TO A DT	ENGINEERING CHANGE NOTICE NO.			07038			SHEET 1 OF 2	
DARI	DWG NO.	651.9900	REV: N/C TO A	PREPARED BY K. TA	ILOR DATE	: 04-20-2	23 ECR :	1554
AEROSPACE	DWG TITLE:	BAYONET	•		•			
APICAL INDUSTRIES, INC. dba DART AEROSPACE	APPROVED BY: ENGI	John			CASE NU N/A		REASON CODE	: MDI
TRANSACTION CODES (TC): A-ADD C-CREATE R-REVISE D-DELETE	REASON: REVIS	SED TEMPLATE AN INSIONS. TIGHTEN	ND VIEWS FOR CLANED HOLE TOLERA	ARITY. REVISED 1 NCE. ADDED N	NOTES. REMOVED OVE OTE TO NOT BREAK BA	ERCONSTRAI YONET TIP.	INING AND RE	:FERENCE

ENGINEERING CHANGE NOTICE NO. 07038

5. PART CONTROLLED BY SOLIDWORKS MODEL P/N 651.9910 REV N/C DATED 04/19/18								
SHEET 1, TOP VIEW AND SECTION A-A WAS:								
		(Ø.240±.002	—				
Ø.180±.005	→ .770±.005			-	—(1.442±.002)	-		
\			^				-(.660±.005)	
î \			î			a A		á

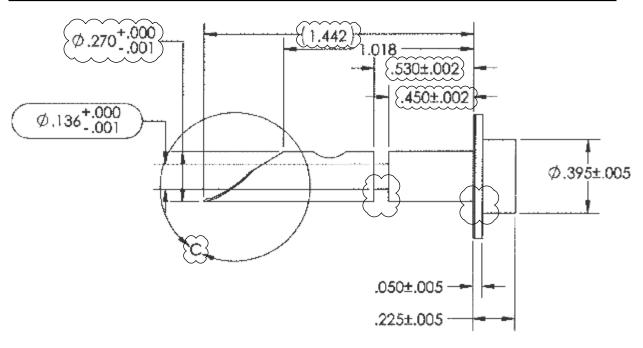
SHEET 1, NOTE	S WAS:							
NOTES:								
1 UNLESS OTHERW	ISE SPECIFIED DEBL	IRR AND BREAK	ALL SHARP EDGES		}			
	WEST STEEL ST A LINE	<u>~~</u>)			
MATERIAL STAINLESS STEEL 17-4 H900.								
IDENTIFY (AW MPP-120 P/N & S/N \ \ \ 0.0025".)								
FINISH IAW MPP-172 PASSIVATE PER SECTION (6.0.)

* H		32.00	» ———		/		ŧ
				4				
					///	\ _		
						\ \		
{	R.010±.002		2.710±.002		_	\	(59.00°)	
					SECTION A-A	\-	/	(Ø.355±.005)
DOCUMENTS AFFECTED:	□ PATTERN □ N	ADL INSTALL INSTE	ructions 🗌 ica 🗀]fms 🗆 bom	CHANGE CATEGORY		IEW REQUIRED	
				· · ·	☐ MAJOR ☒ MINOR	_] YES ⊠ N	10
